Documentation of Public Hearing

US Highway 290 (US 290) / State Highway (SH) 71 West
0013-08-060 and 0700-03-077

Project Limits
From State Loop 1 (MoPac) to Ranch-to-Market (RM) 1826
and from SH 71 to Silvermine Drive

Oak Hill Parkway (US 290/SH 71 West)
Comment/Response Matrix
Public Hearing - May 24, 2018

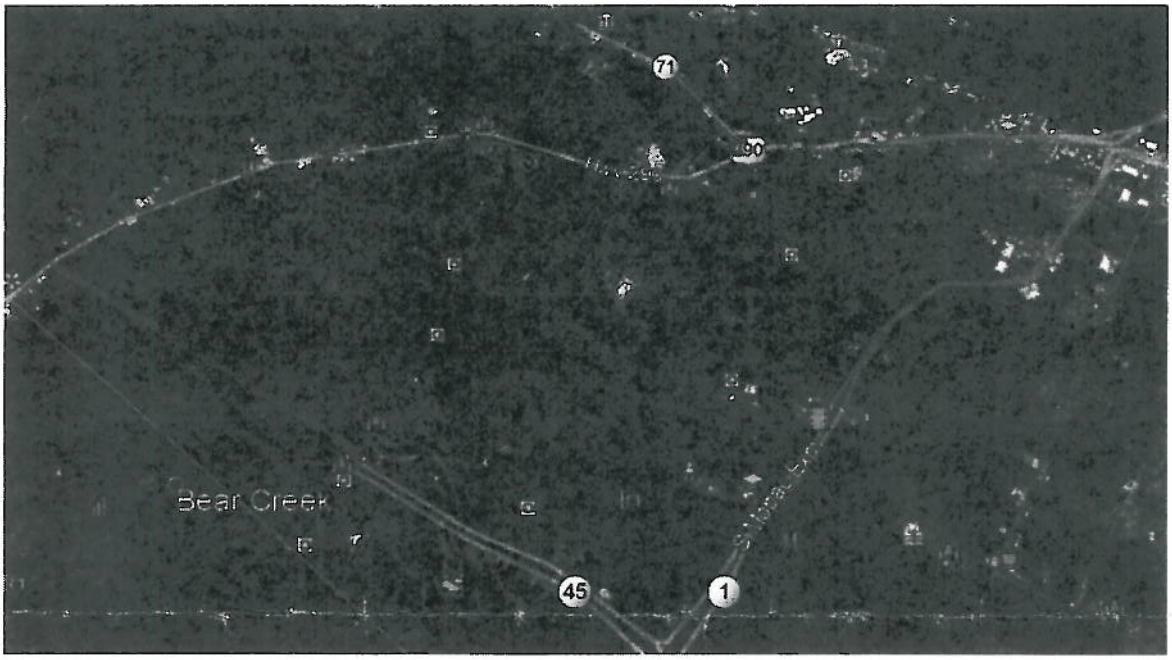
The extension of SH 45 from FM 1826 to US 290 (bright green line in map below) has a lower cost (probably far less than $230 Million including land acquisition) and a lower environmental impact than Schematic "A" as proposed.

Plan View of US290/SH71 profile from William Cannon on US290 to Scenic Brook on SH71. This image was composited from the Draft EIS, May 4, 2018, Appendix A, pages 24, 25, 29 and 30. A larger scale is presented at the end of this report.

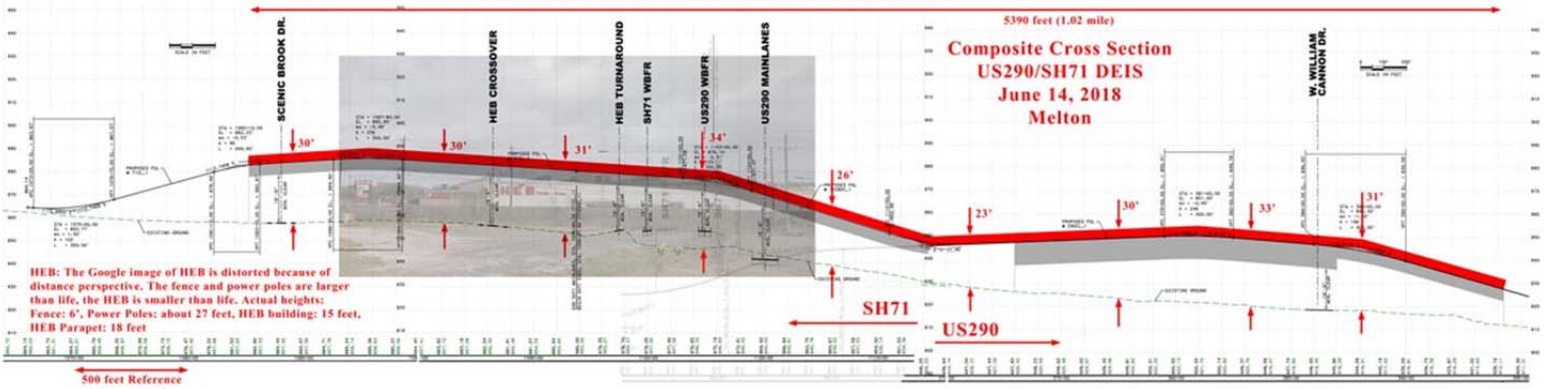
6', Power Poles: about 27 feet, HEB building: 15 feet, HEB Parapet: 18 feet. A larger scale drawing is included at the end of this document.

2) FRONTAGE PHASING REVERTS CONGESTION BACK TO 2010

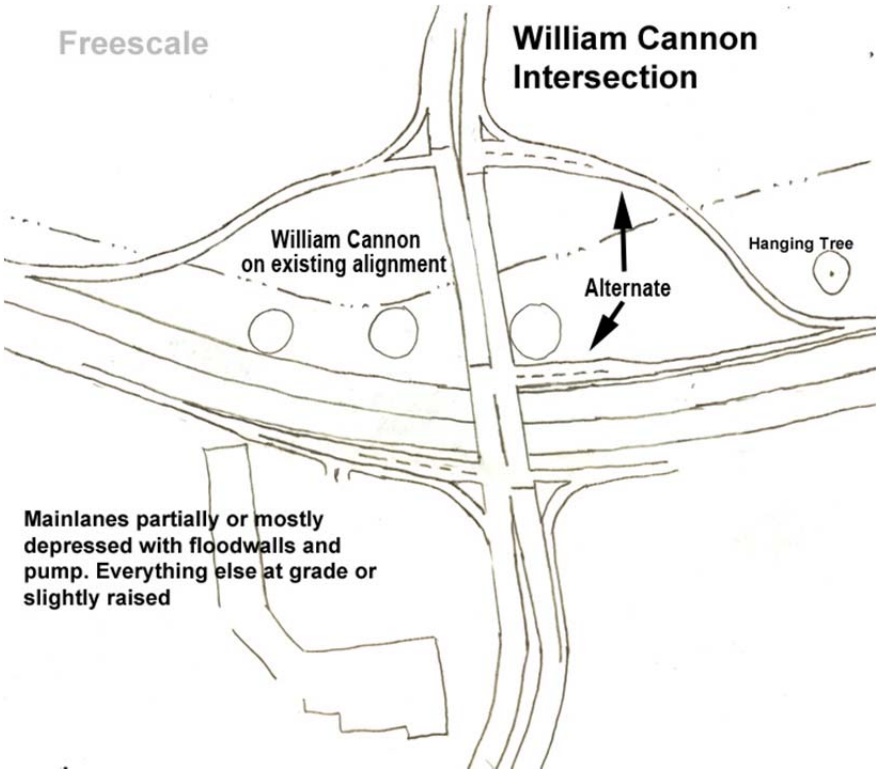
(Priority) William Cannon Overpass at Oak Hill Center Retail: We can't lose the retail on the SW corner. A conceptual economic evaluation needs to be performed on these alternatives:
1) ***Use the main lanes depressed solution, or use a partial depressed solution—both with retaining walls to keep out flood and a pump system like is common in Gulf Coastal regions. William Cannon will work just fine on its existing alignment as well. A sketch is attached.***

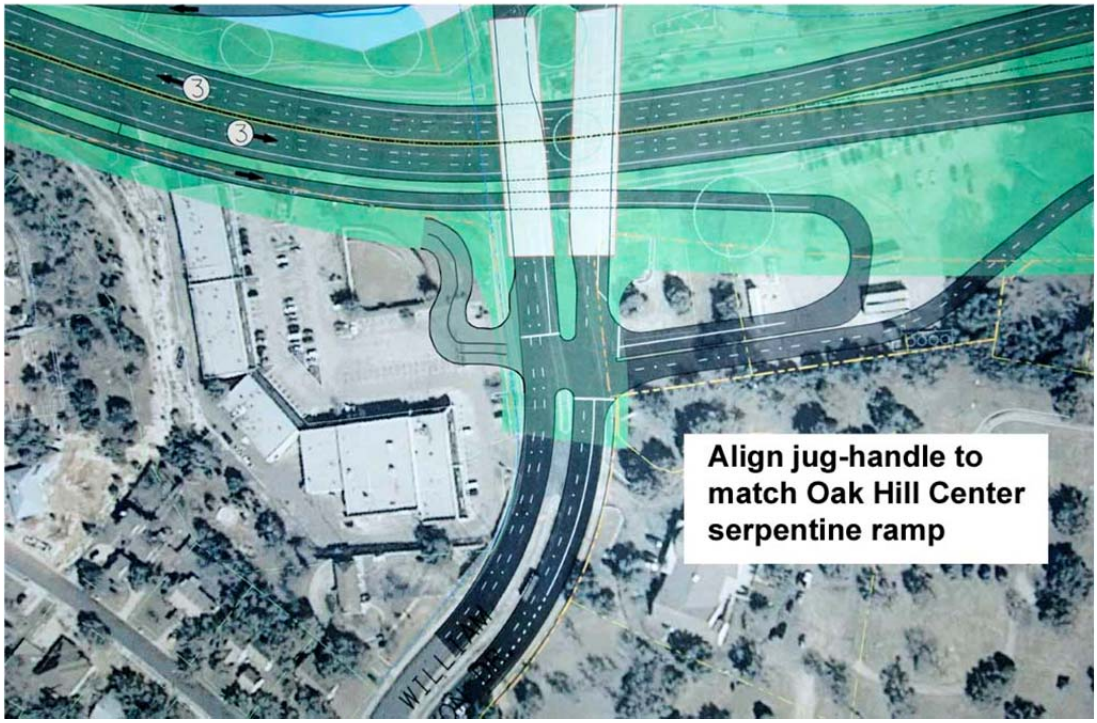
2) Develop a solution where this retail center has a driveway on the eastbound frontage ramp similar to the other alternatives. Width constraints are less for this alternative than some of the other alternatives where an eastbound ramp access is included and an access at this point should be feasible.
2) Design a serpentine ramp to access the Oak Hill Center from William Cannon as shown in the sketch below.
3) Angle the alignment of William Cannon even farther to the east to create more room for an access

ramp to the Oak Hill Center.

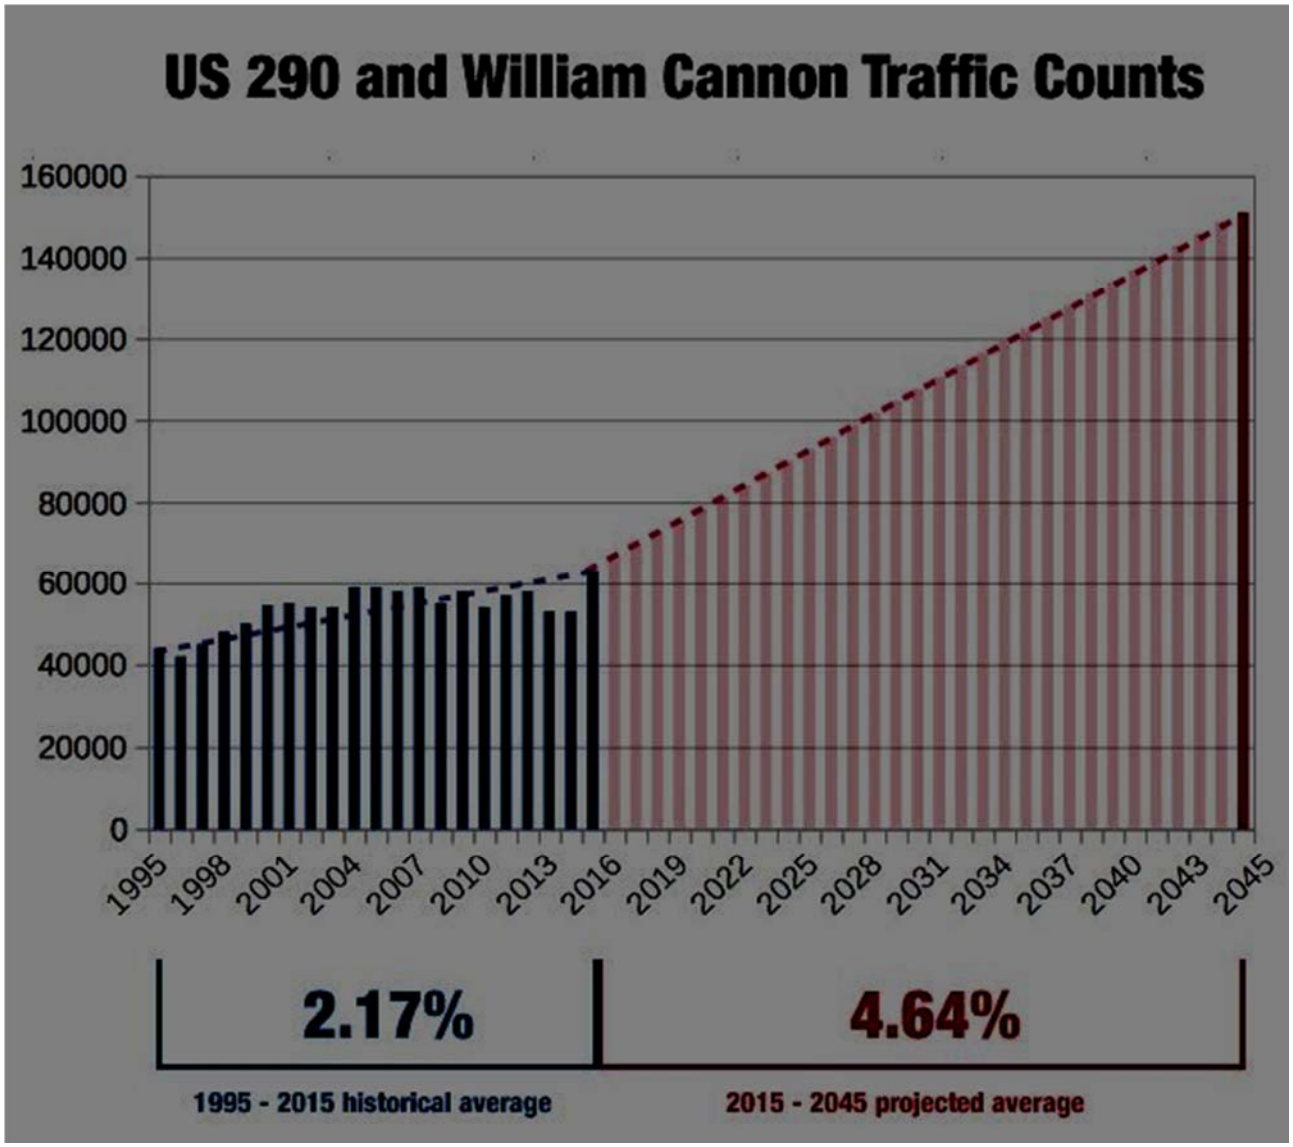
5. Suspect future traffic projections contradict the known evidence from past experience.

Besides the suspect forecasting, "backcasting" using projections published in the 1988 EIS reveals that traffic counts at the "Y" in Oak Hill are still not as high as TxDOT said they would be in 2005.
